TENDER DOCUMENTS ADDENDUM

PROJECT: Drumheller Memorial Arena – Dressing Room Addition
ADDENDUM NUMBER: 4
DATE: April 17, 2023
NUMBER OF PAGES: 5 + Attachments

(P) PILE SCHEDULE

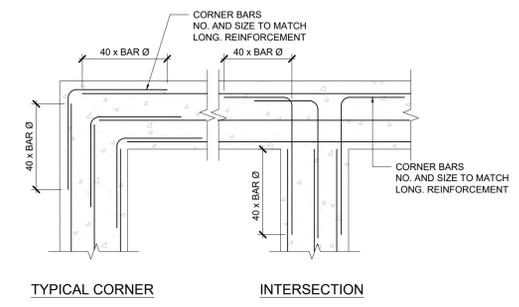
13. Refer to revised Pile Schedule on S1.0 (attached). Note that the Pile Loads (KN) have been added to the schedule. Alternate designs for piles will be accepted provided that the proposed design meets the load requirements, soil conditions, and is undersigned by the Contractor's engineer registered in the Province of Alberta.
14. Refer to new Detail 12 Section @ Existing Lower Roof, S1.1 (attached). Existing wall at Grid 3, between Grid A and A-A requires extension.

MARK	SHAFT DIAMETER	SHAFT REINFORCEMENT	TIES	PILE LENGTH (m)	T/O PILE ELEVATION (mm)	PILE LOAD (KN)
P1	508	(6)-15M	(3)-10M @ 50 O/C TOP & BOTTOM REST: 10M @ 400 O/C	6.0	99205	94
P1a	508	(6)-15M	(3)-10M @ 50 O/C TOP & BOTTOM REST: 10M @ 400 O/C	7.0	100105	112
P1b	508	(6)-15M	(3)-10M @ 50 O/C TOP & BOTTOM REST: 10M @ 400 O/C	6.0	98888	27
P2	508	(6)-15M	(3)-10M @ 50 O/C TOP & BOTTOM REST: 10M @ 400 O/C	9.0	99205	201
P2a	508	(6)-15M	(3)-10M @ 50 O/C TOP & BOTTOM REST: 10M @ 400 O/C	10.0	100105	183
P3	610	(8)-15M	(3)-10M @ 50 O/C TOP & BOTTOM REST: 10M @ 400 O/C	10.0	99205	263
P4	610	(8)-15M	(3)-10M @ 50 O/C TOP & BOTTOM REST: 10M @ 400 O/C	12	99205	388
